**BSR/ASHRAE/IES Addendum p
to ANSI/ASHRAE/IES Standard 90.1-2025**

**Proposed Addendum p to
Standard 90.1-2025, Energy Standard
for Sites and Buildings Except Low-
Rise Residential Buildings**

**First Public Review (August 2026)
(Draft Shows Proposed Changes to Current Standard)**

Addendum p to 90.1-2025

Figure K-6

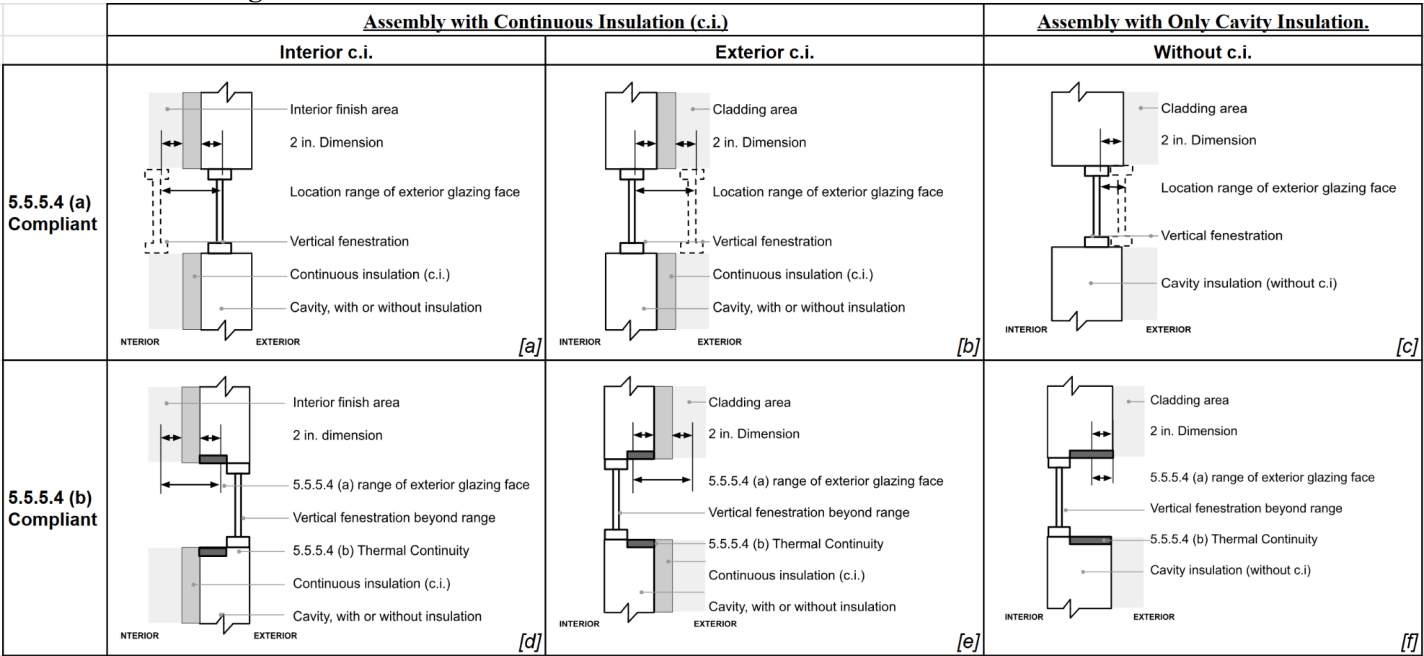
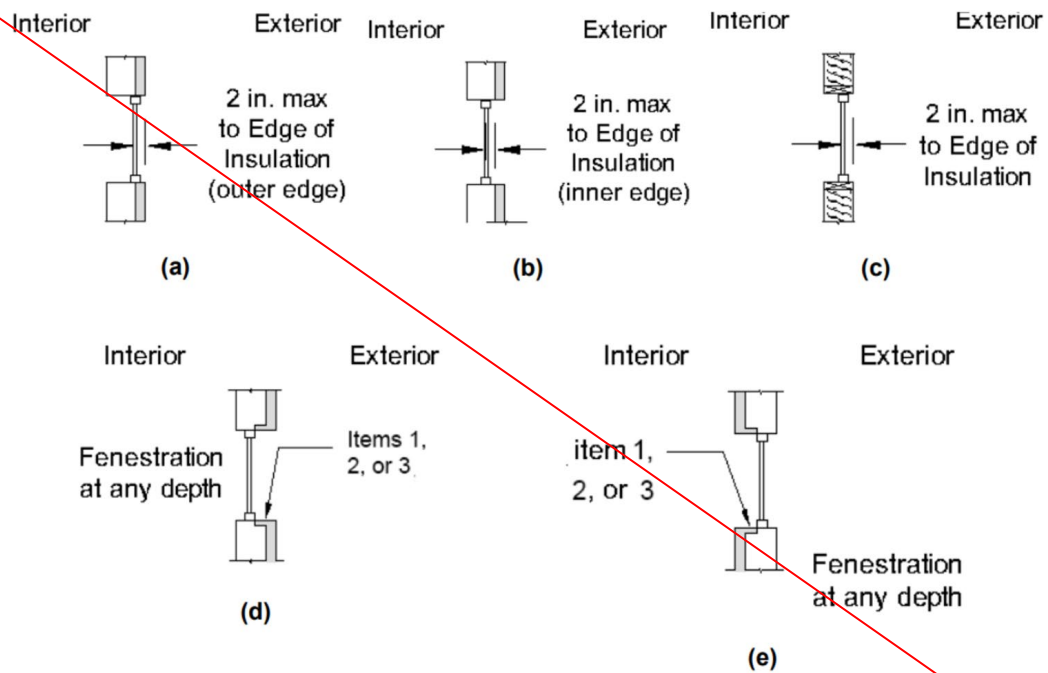
The most significant clarification is the rewording of item (b), which is now identified as an alternative compliance path to item (a). This change is intended to eliminate ambiguity and ensure that all compliance options are clearly understood. Drawings in Informative Appendix K were revised for clarity.

Update Figure K-6 in Appendix K by removing the old figure and replace with new image;

Remove existing Figure K-6 (below)
